APPLICATION FOR SUBMITTAL OF POST-APPROVAL DOCUMENT

2. PROJECT INFORMATION:			
School District/Owner: <u>Bakersfield City School District</u>		DSA File Number: <u>15 6</u>	
Project Name/School: <u>Dr. Martin Luther King Jr. Elementary School</u>		DSA Application Number <u>03 122605</u>

ADDENDUM NO. 2
PROJECT MANUAL
MLK ELEMENTARY SCHOOL
WELLNESS CENTER
BAKERSFIELD CITY SCHOOL DISTRICT

Project No.: 5527
DSA File No. 15-6
DSA App No. 03-122605
December 19, 2024

Sheet No.:
A3.11

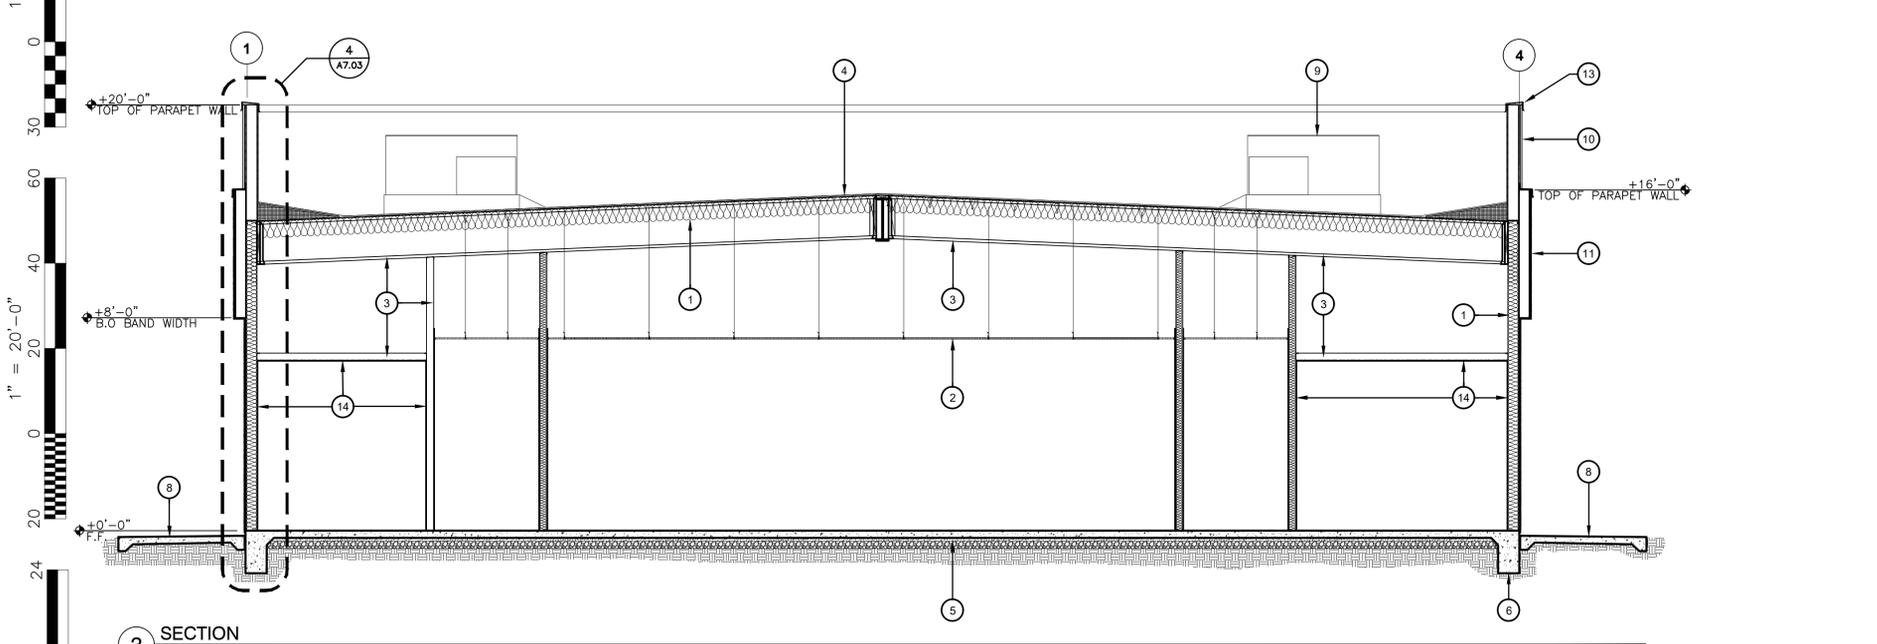
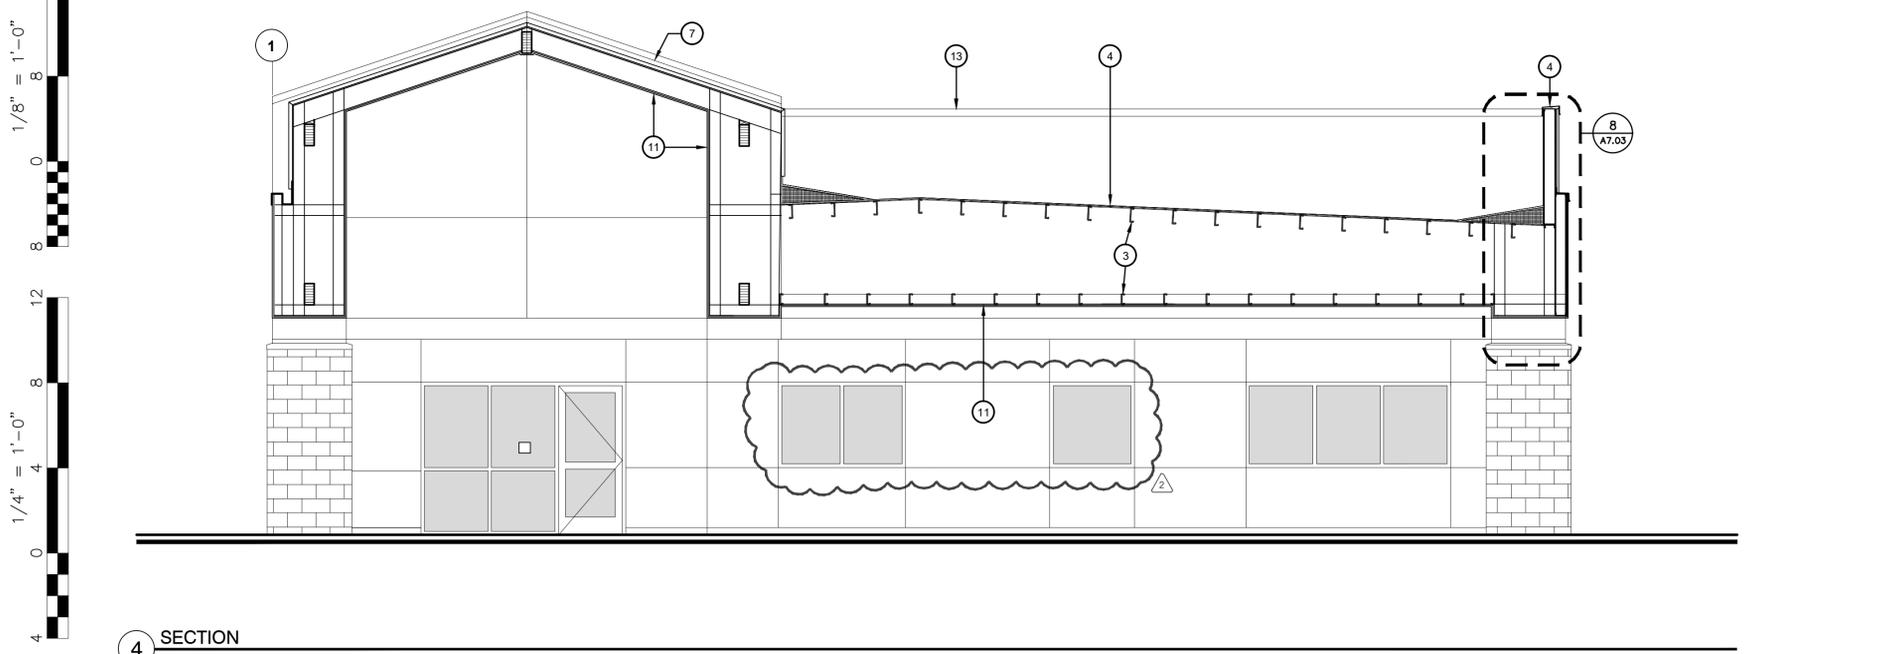
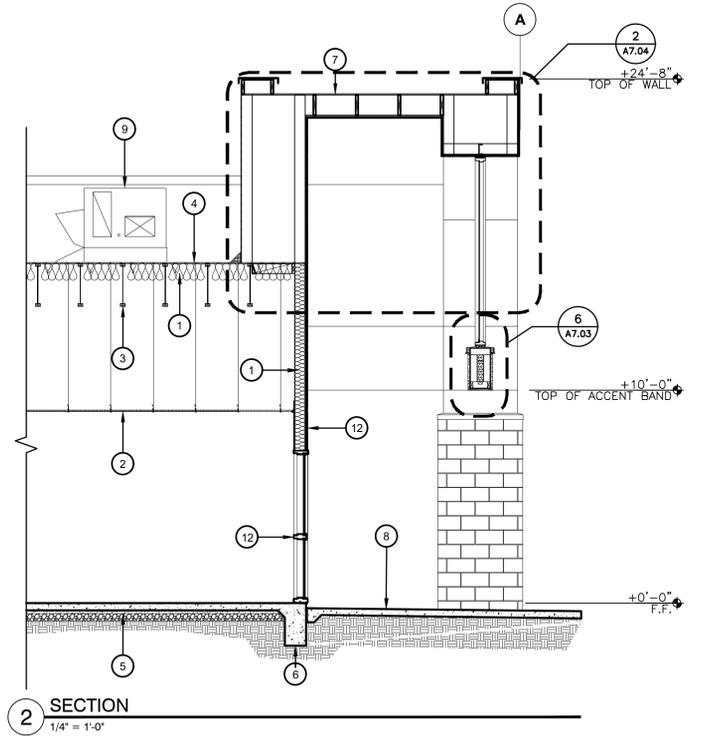
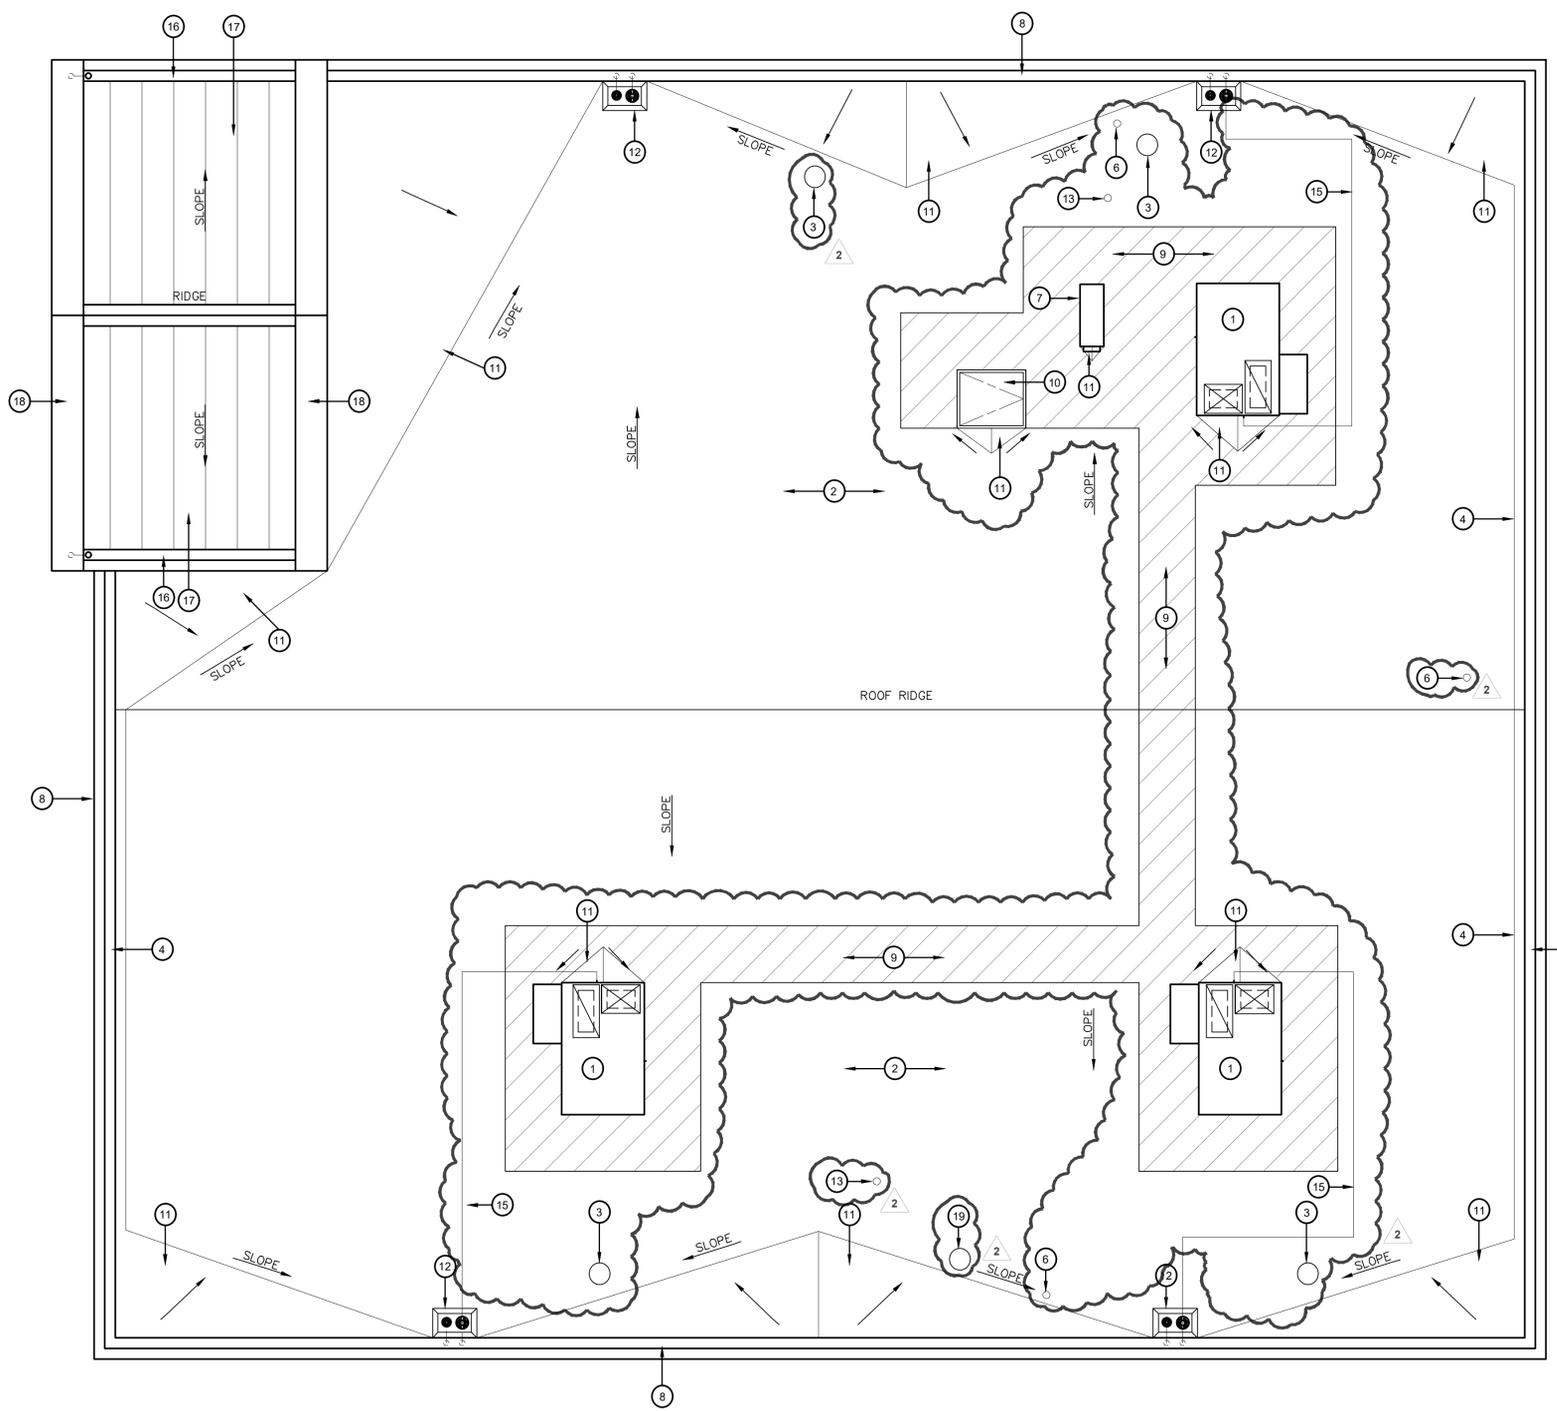
2-13 DRAWING, SHEET 3.11 – SECTIONS: Note the following changes (See A3.11 Addendum 2 drawing)

Sheet No.:
A4.10

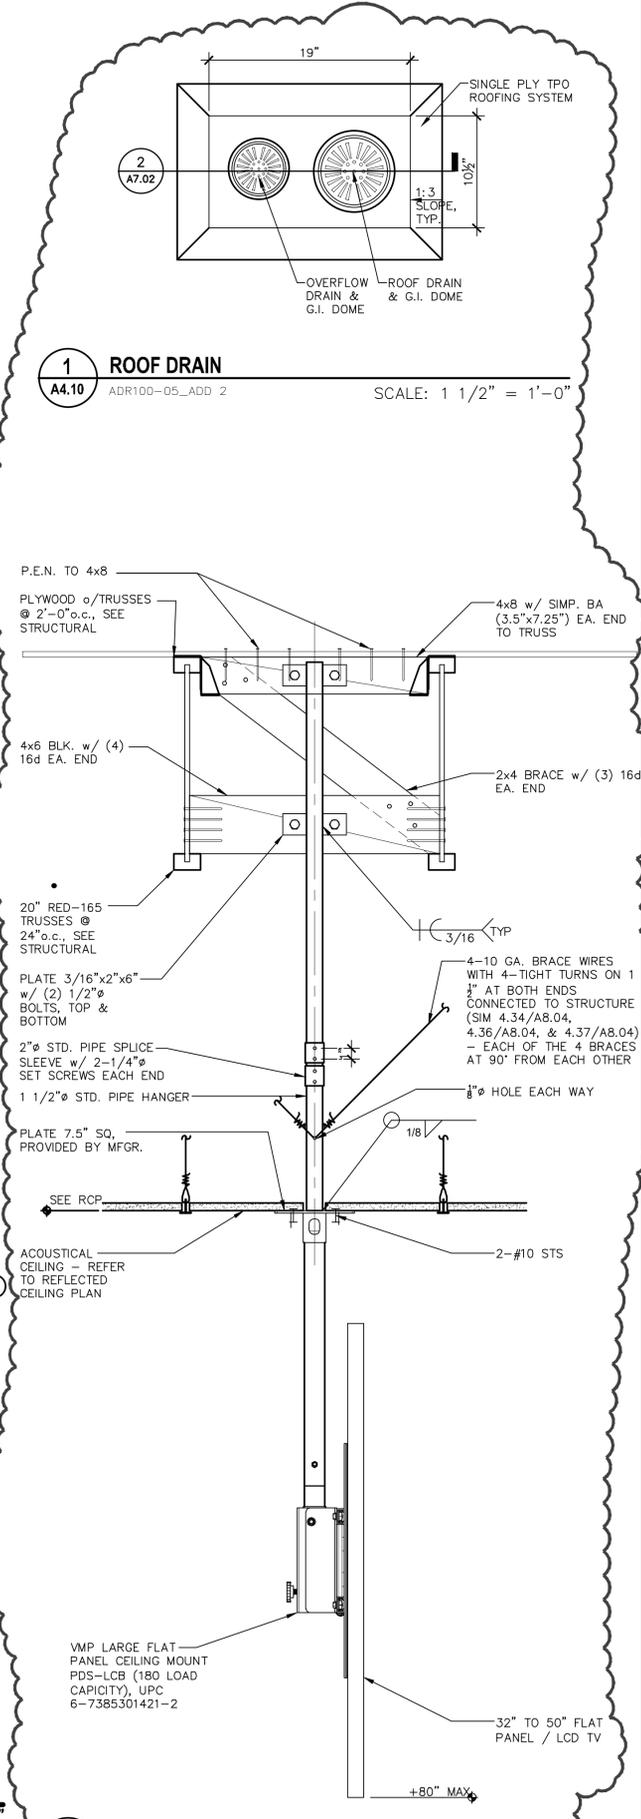
2-14 DRAWING, SHEET A4.10 – ROOF PLAN: Note the following changes (See A4.10 addendum 2 drawings):

1. Revise key note 12.
2. Add exhaust fan vent. See keynote 3.
3. Add roof walk mats. See keynote 9
4. Add hose bibb. See keynote 13.
5. Add roof vent penetrations. See keynote 16.
6. Add condensate pipe. See keynote 15.
7. Add details 1 and 2/A4.10.

Sheet No.:
A5.10

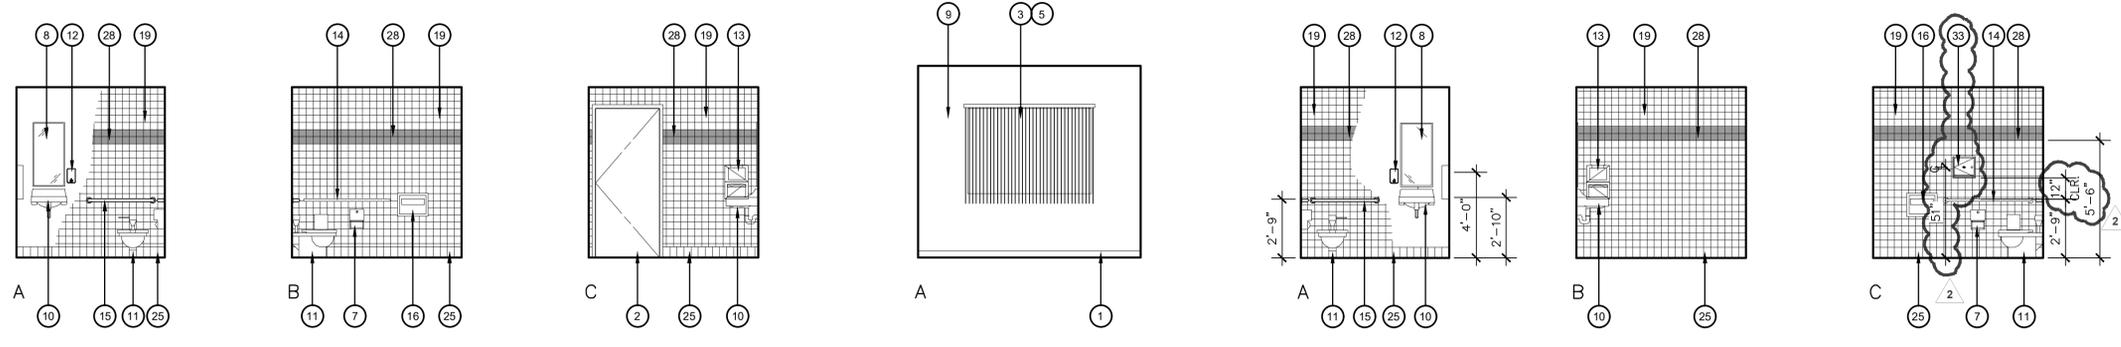
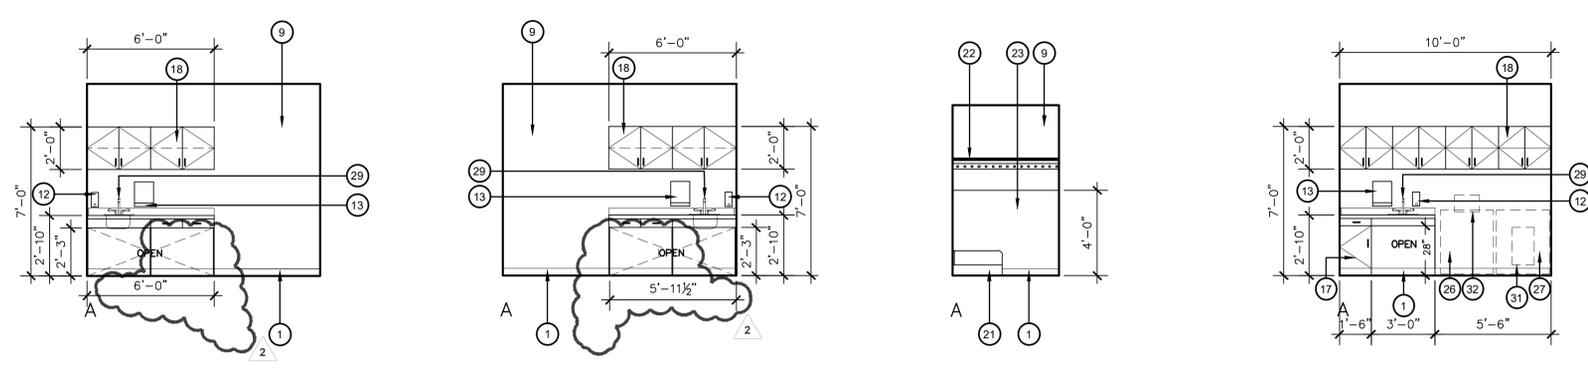
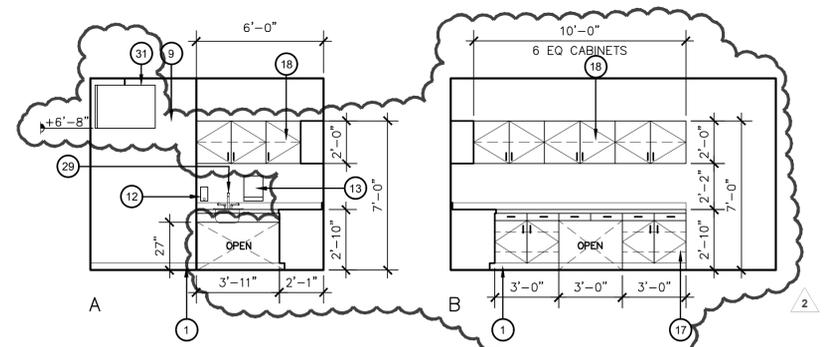
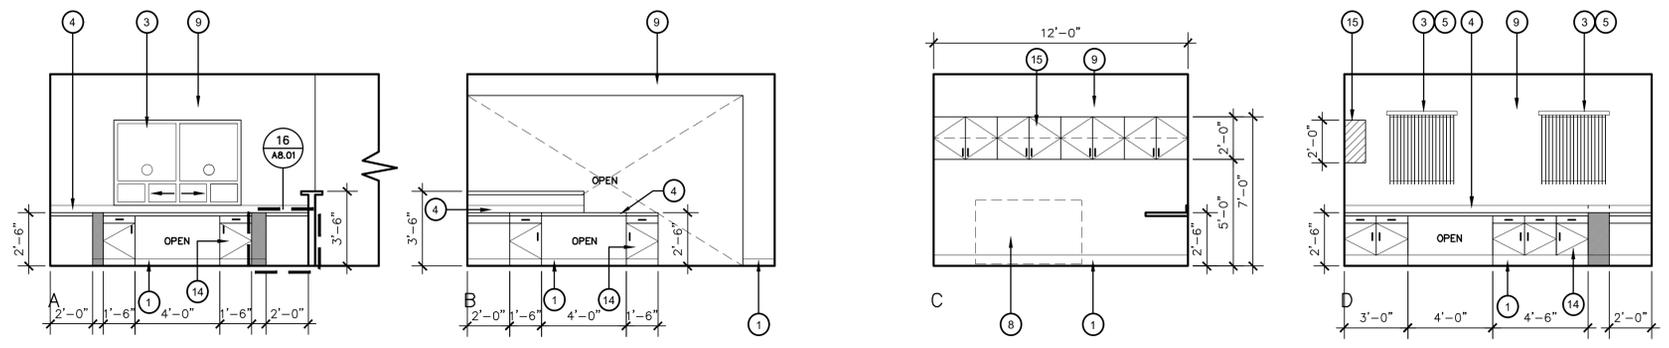
2-15 DRAWING, SHEET A5.10 – INTERIOR ELEVATIONS: Note the following changes (See A5.10 addendum 2 drawings):

- i. Add TV. See keynote 34.
2. Elevation “C” lobby 101:
 - i. Add TV. See keynote 34.
3. Elevation “C” unisex toilet 104:
 - i. Add pass through cabinet. See keynote 33.
4. Exam rooms 106, 108, 112 and 107, 109, 110:
 - i. Remove base cabinets. Provide countertop with drawers.
5. Medical assistant office 105:
 - i. Add elevation “B” for added cabinets.
 - ii. Modify elevation “A” to add TV.
6. Delete elevations office room 116.
